**September 10, 2024**

**The Reserves at Grand View Heights – Proj. 22-3262**

**ADDENDUM NO. 3**

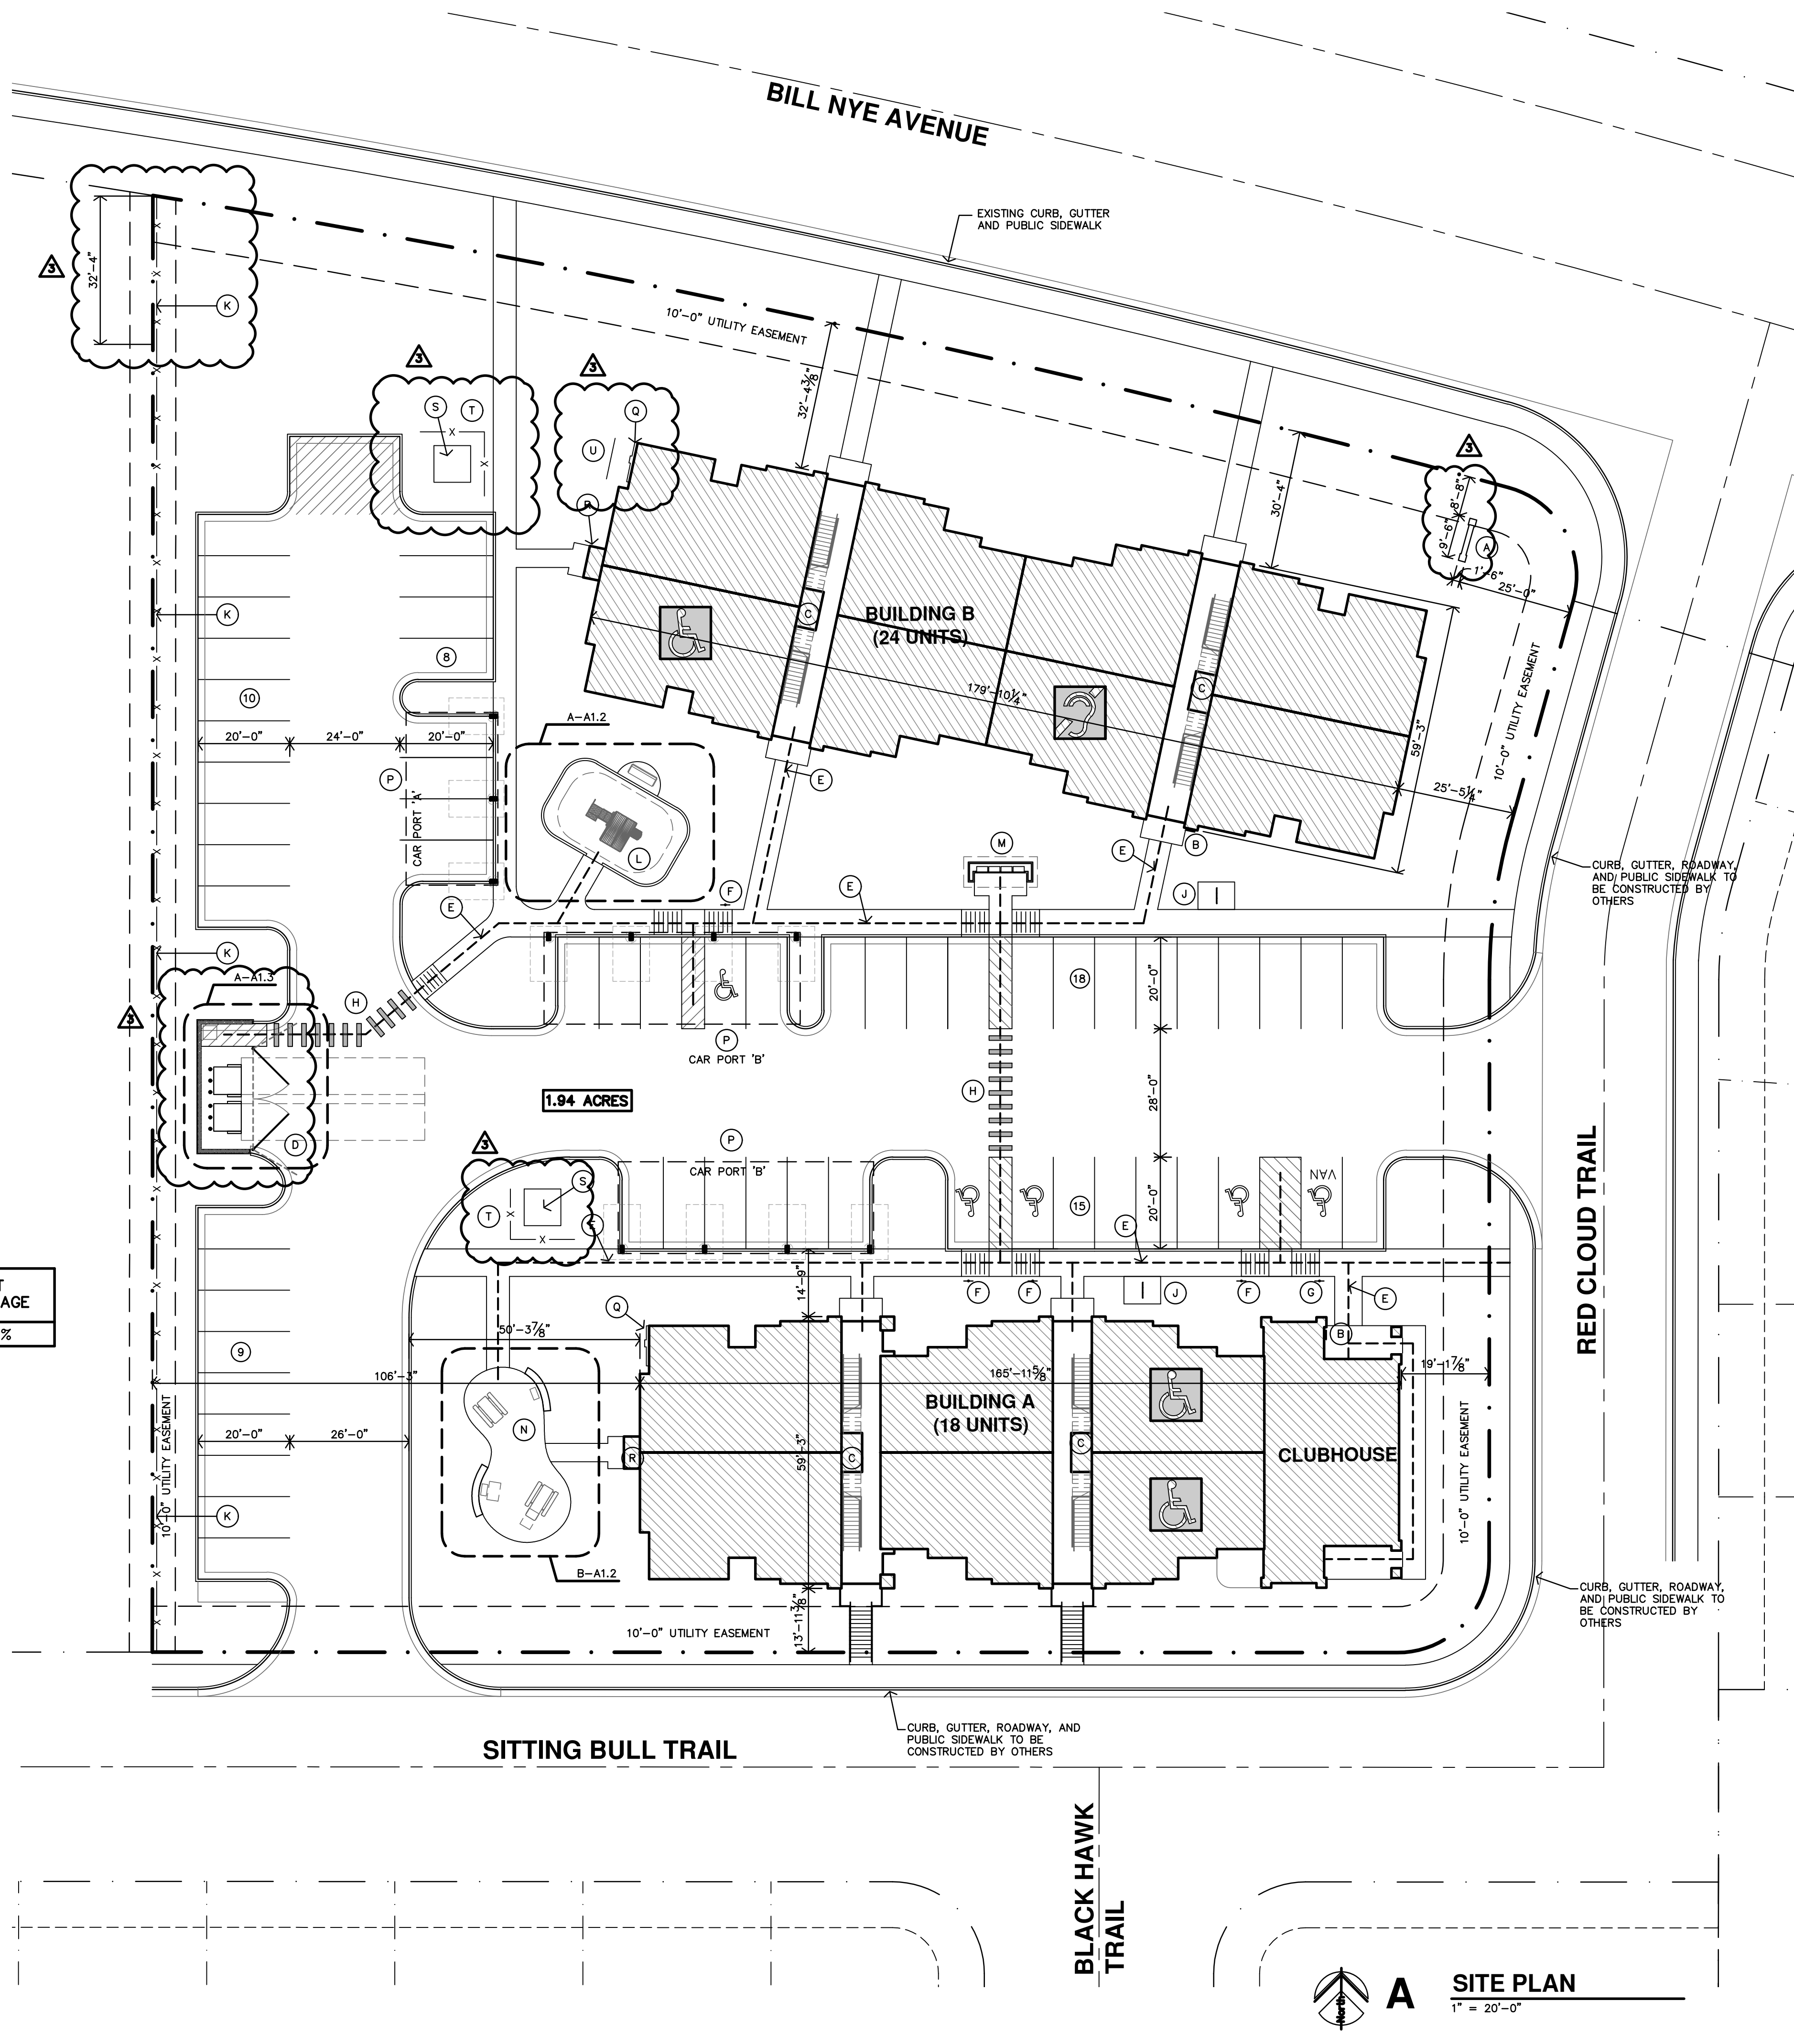
1. Sheet A1.1
  - a. Perimeter fence, along west property line – Along north end, for a minimum of 32'-4" from the property line, the fence must be 4' in lieu of 6' tall.

- b. Transformers shall be buffered by 5' tall wood fences. Reference Notes T on the Site Plan Key Notes. Reference plan for location of fence.
  - c. Electrical panel on Building B shall be buffered by a 5' wood fence. Reference Note U on the Site Plan Key Notes.

- d. Trash Enclosure has been enlarged (North wall shifted north), and dumpsters/bollards shifted north, to provide proper clearance around the dumpsters.

- e. Monument Sign size has been adjusted, made smaller.
2. Sheet A1.2
  - a. Detail J has been revised to include details for the 4', 5' and 6' tall fences.

**J MONUMENT SIGN SECTION**  
3/4"=1'-0"

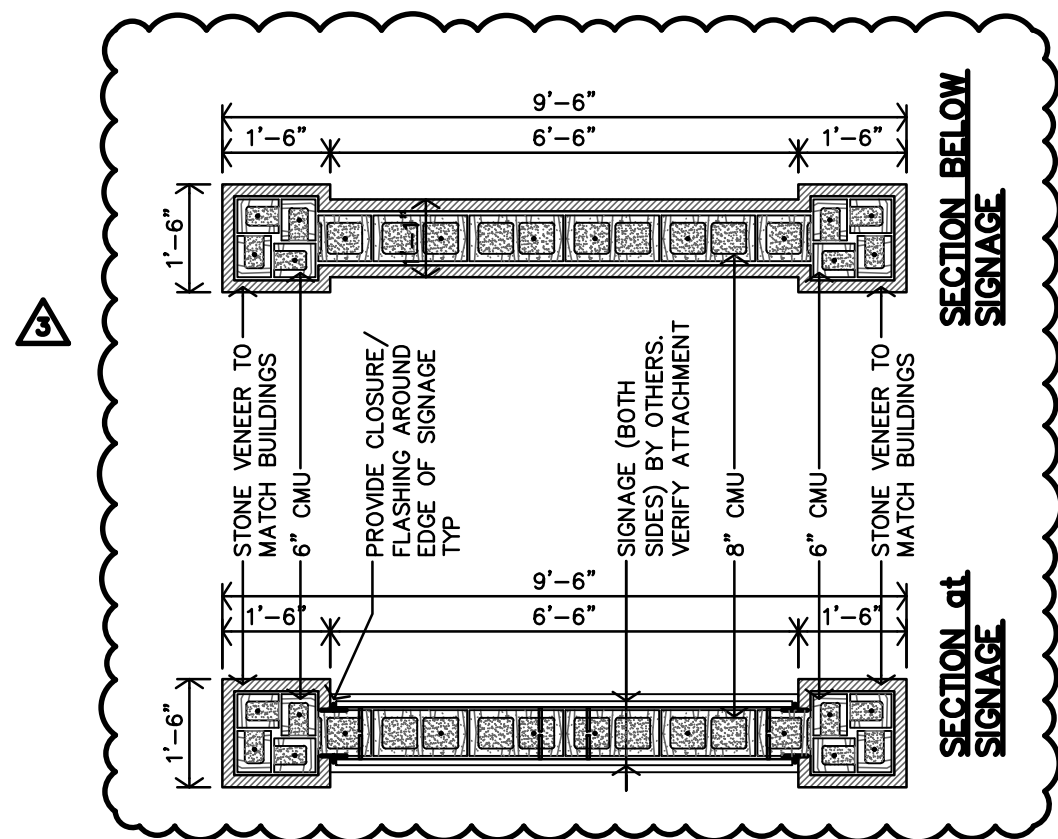
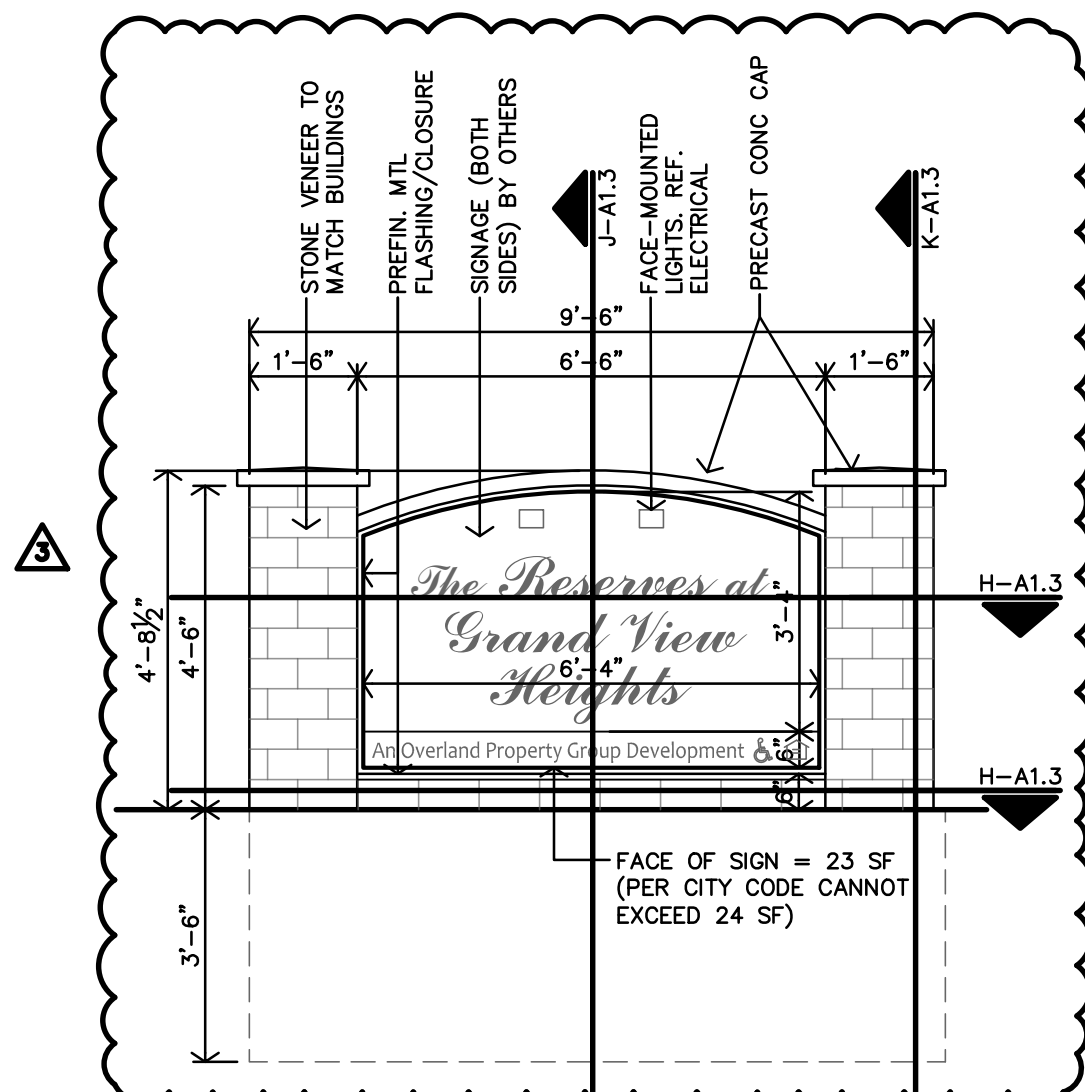
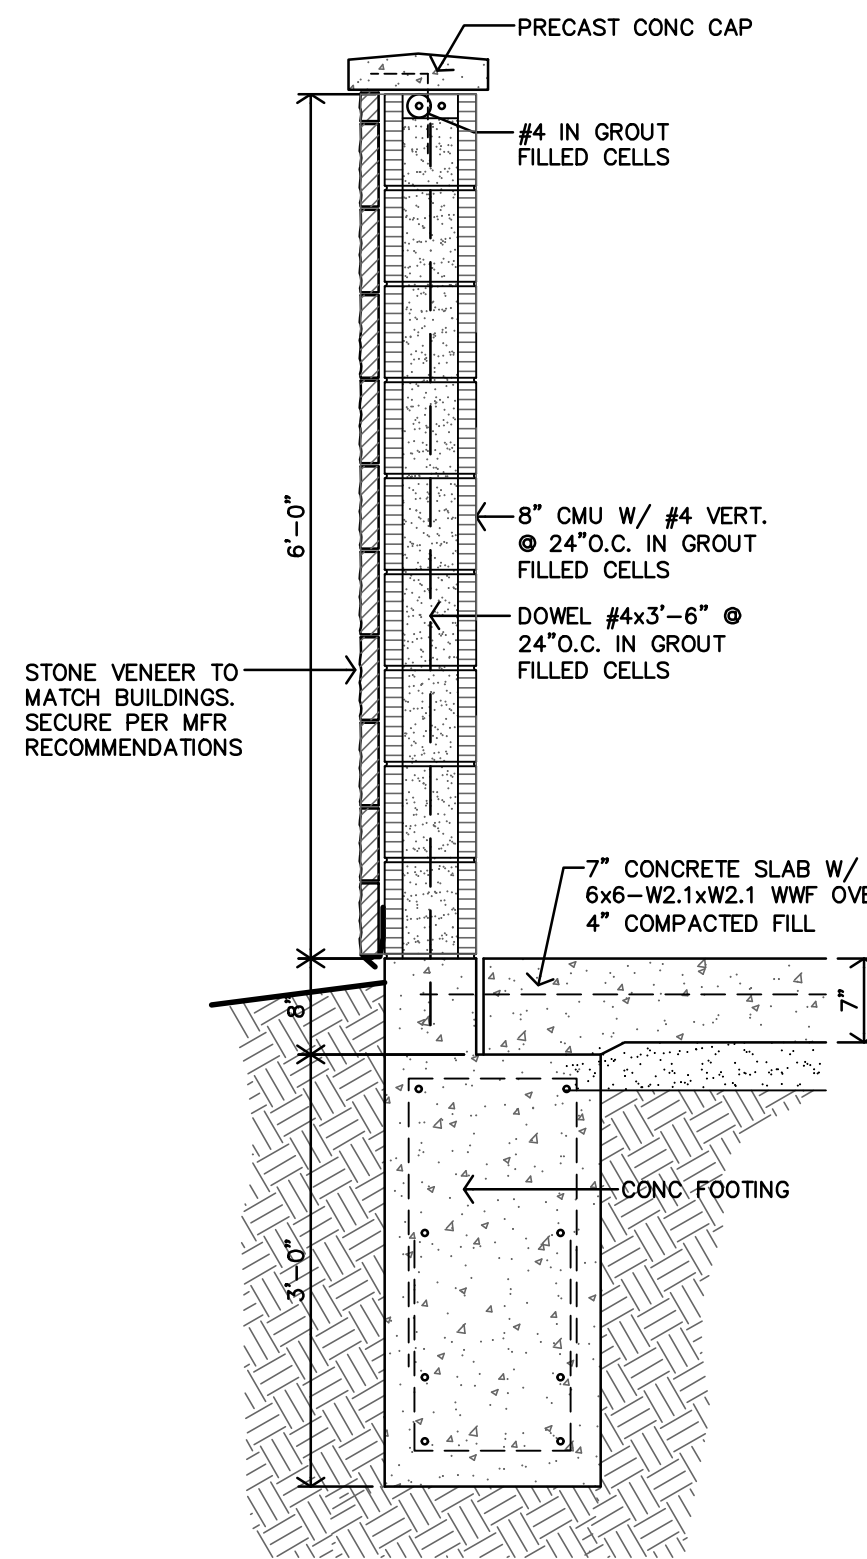
- b. Monument Sign size has been adjusted, made smaller. Reference revised details G, H, J & K.
4. Sheet L1.1
  - a. Entire Plan has been updated to include additional plantings and landscaped areas per Laramie Municipal Code.
